Subject: UniStar Nuclear Energy, NRC Docket No. 52-016
Response to Request for Additional Information for the
Calvert Cliffs Nuclear Power Plant, Unit 3,
RAI 218, Stability of Subsurface Materials and Foundations

Enclosure: Response to NRC Request for Additional Information RAI 218 Question 02.05.04-08, Calvert Cliffs Nuclear Power Plant, Unit 3.

RAI 218 Question 02.05.04-08,

Calvert Cliffs Nuclear Power Plant, Unit 3

Figure 1 – Capacity Diagram

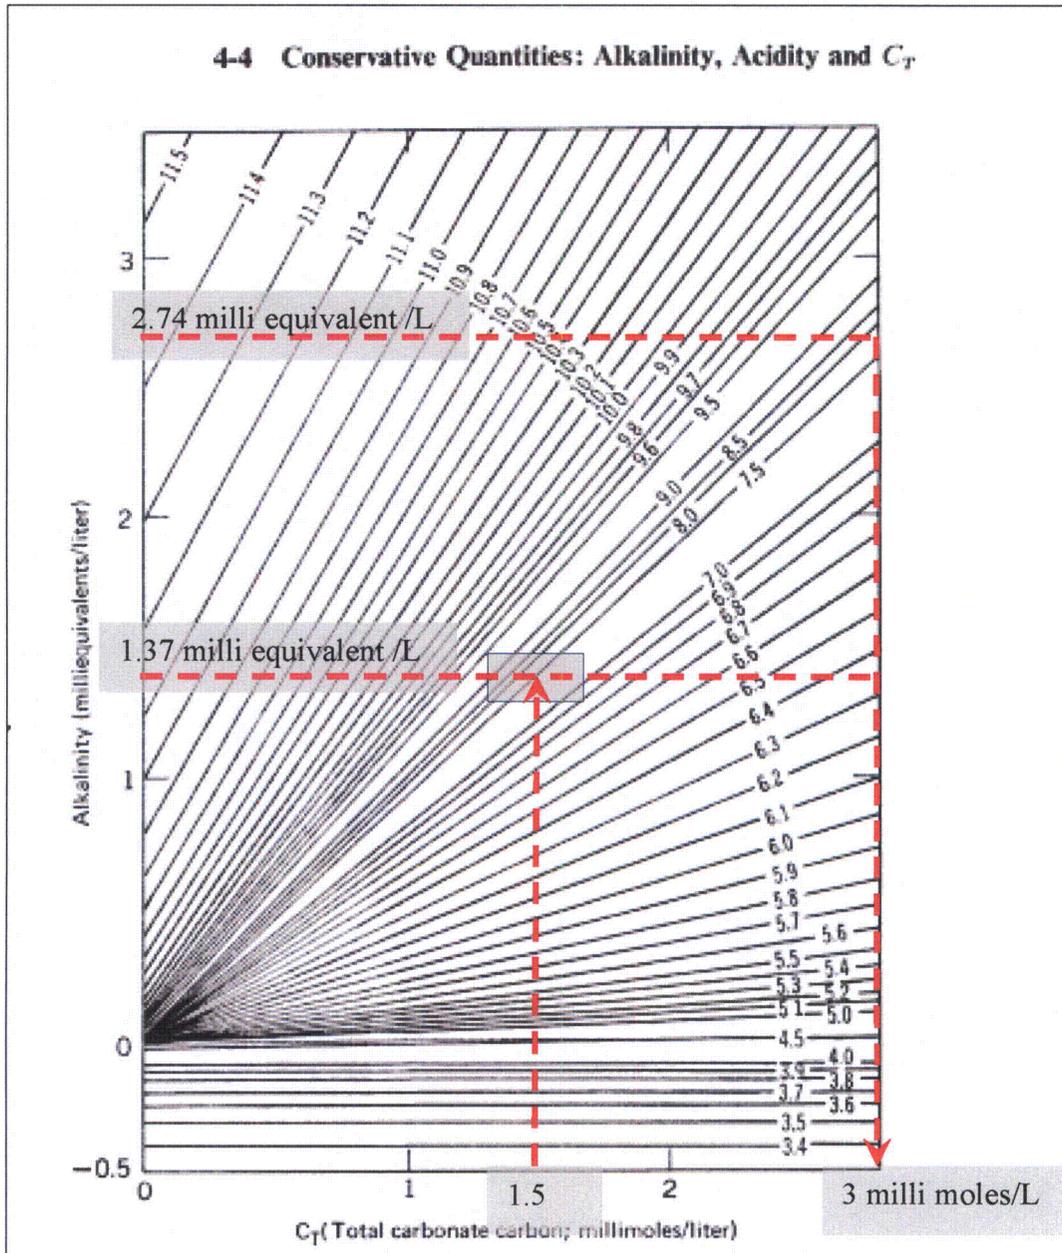
Section 2.5.4.2.2.2 states that dolomite or calcite was identified as the cementing agent for the sand soil layer and the absence of dolomite or calcite in certain parts of the layer might be due to low pH groundwater. Since most of the Category I structures will be founded on the cemented sand, please discuss the possible soil strength reduction caused by the low pH ground water entering the cemented sand layers, and subsequently breaking the soil particles bond.

In order to confirm the acid neutralizing capacity of the UCU aquifer when it mixes with the surficial aquifer, the capacity diagram given by Stumm and Morgan, (1970) is used with the groundwater parameters available from monitoring wells. This diagram (Figure 1) uses constant variables in an

aquatic system (i.e., a groundwater flowing in an aquifer) of alkalinity and total carbonate carbon concentration along with pH contours of the associated solutions. With the help of Figure 1, if one variable is not known, it can be determined from the two known variables. The effect of addition or removal of any acid/base on the pH can be evaluated using this diagram. In other words, the diagram facilitates calculation of the constant variable in equilibrium conditions.

As indicated by the groundwater monitoring results, the Surficial aquifer has essentially zero alkalinity, and with a pH of 5.4, the total carbonate carbon on the diagram is determined as zero from the diagram.

For the UCU aquifer, the alkalinity was calculated conservatively using the minimum alkalinity as 137 mg/L (2.74 mEq/L). Corresponding total carbonate carbon concentration of the UCU aquifer is approximately 3 milli moles/L. The groundwater models described in FSAR Section 2.4.12 have shown that surficial aquifer flow into the UCU aquifer will be limited. However, for this buffering capacity determination, it is conservatively assumed that the Surficial and UCU aquifers mix in equal volumes. Consequently, the alkalinity and the total carbonate carbon of the groundwater when two aquifers mix is calculated as 1.37 mEq/L alkalinity and 1.5 milli moles/L total carbonate carbon by averaging the two variables in equal proportion. The pH value for the mixed groundwater using these parameters is approximately 7.2 (shown as a shaded box on the capacity diagram).

It is concluded that the UCU aquifer has enough buffering capacity to neutralize the Surficial aquifer when they mix after construction. At the neutral conditions, no dissolution of the dolomite and calcite bond will be expected; therefore no strength reduction is anticipated in the cemented sand layer.
